APPROVED DRAWINGS HAVE BEEN RED LINED INDICATING A CHANGE TO MEET THE OBC. PLEASE REVIEW ALL PAGES TO ENSURE YOU ARE PROPERLY INFORMED OF CHANGES.

### TOWNSHIP OF NORTH DUMFRIES BUILDING DEPARTMENT

## Tice River Homes

## Legacy

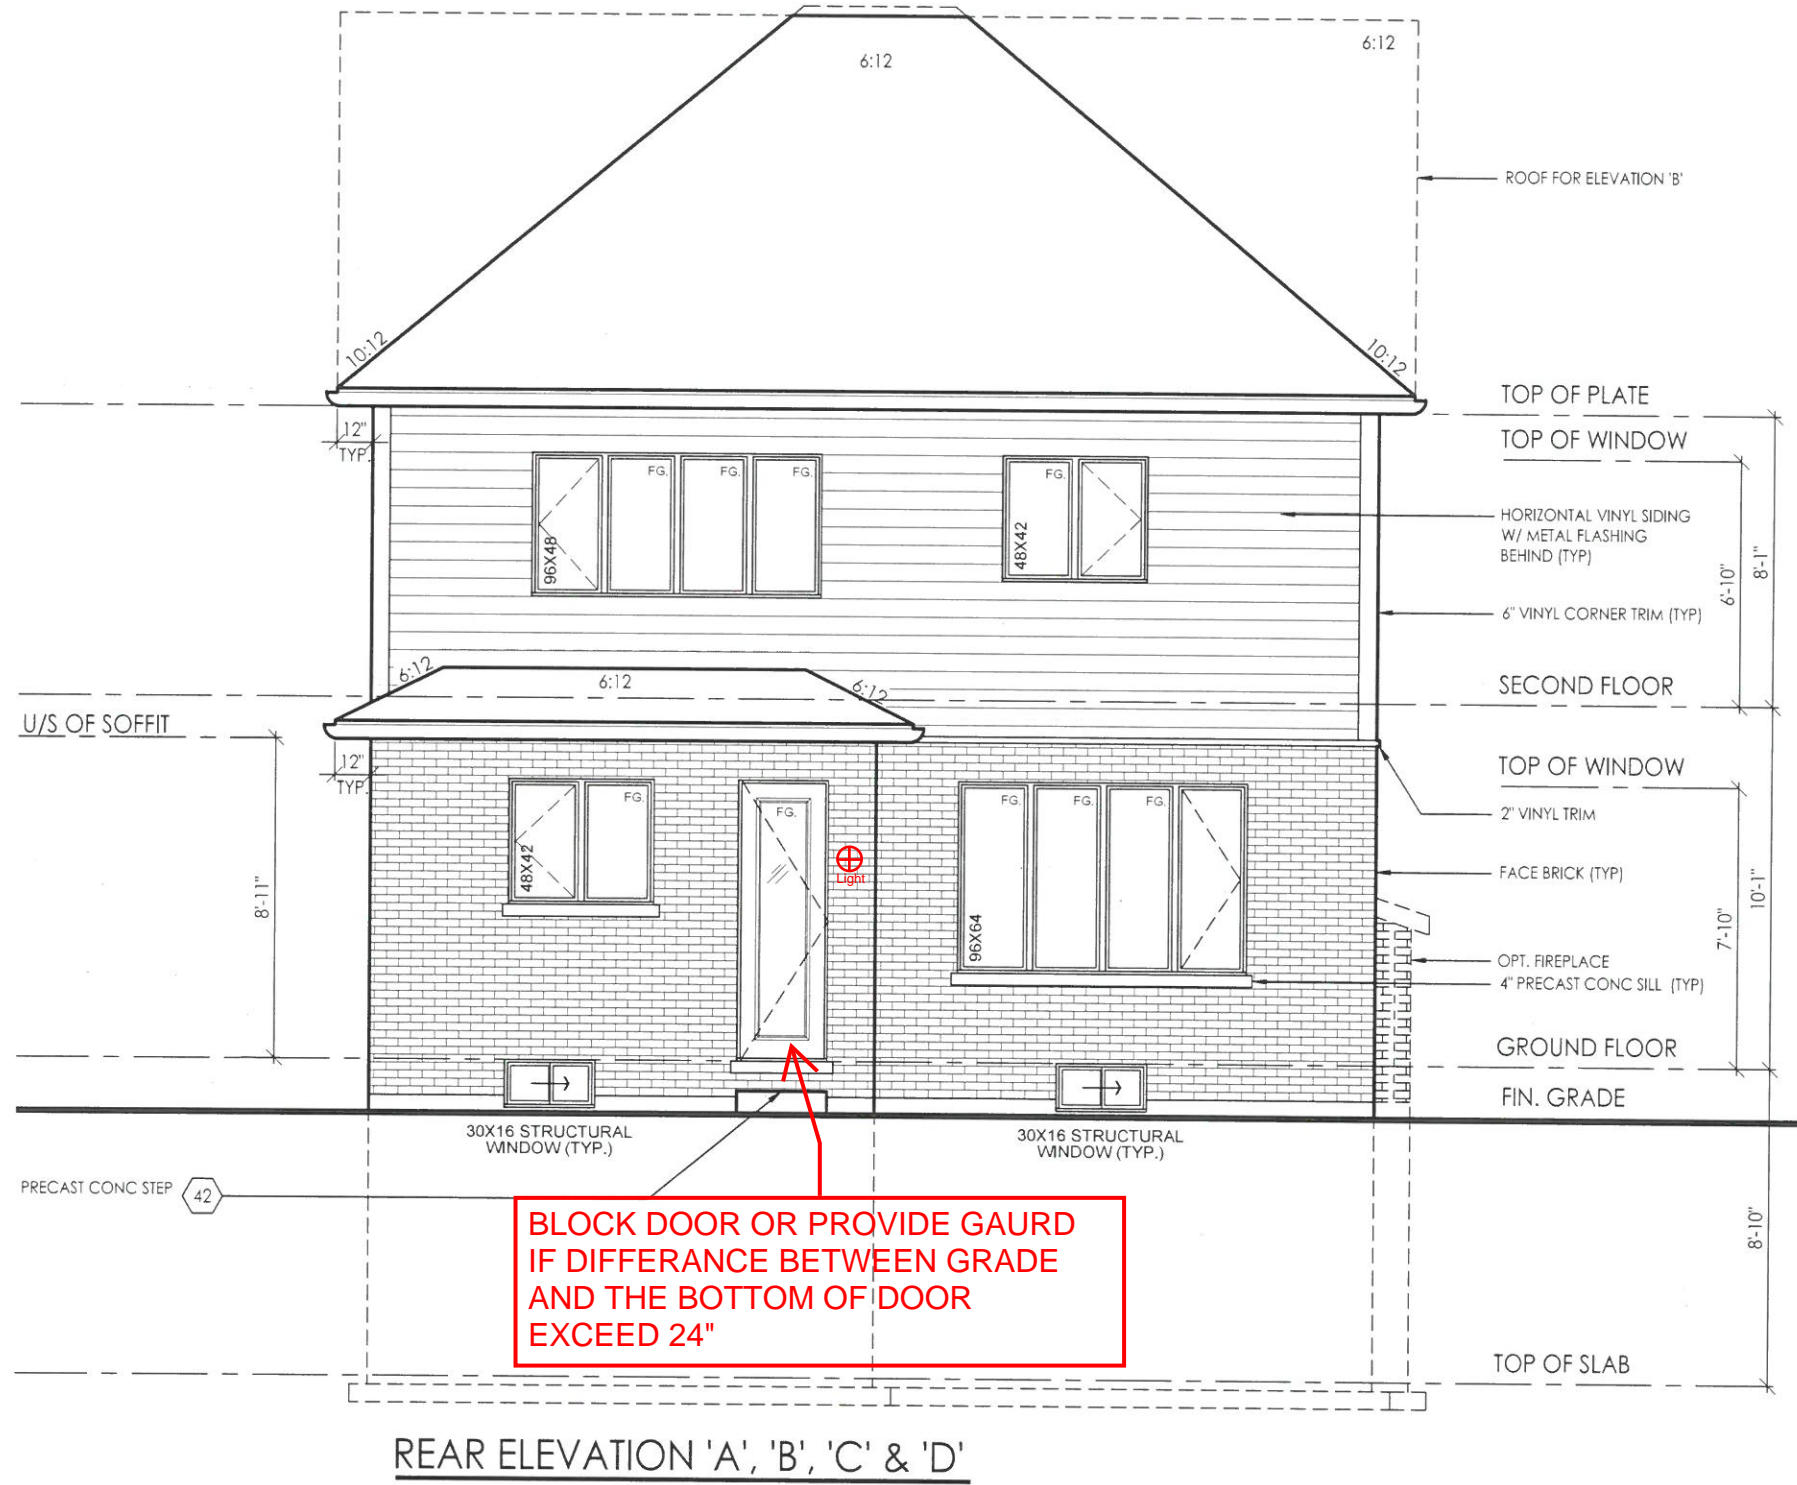
BLOCK DOOR OR PROVIDE GAURD IF DIFFERENCE BETWEEN GRADE AND THE BOTTOM OF DOOR EXCEED 24"
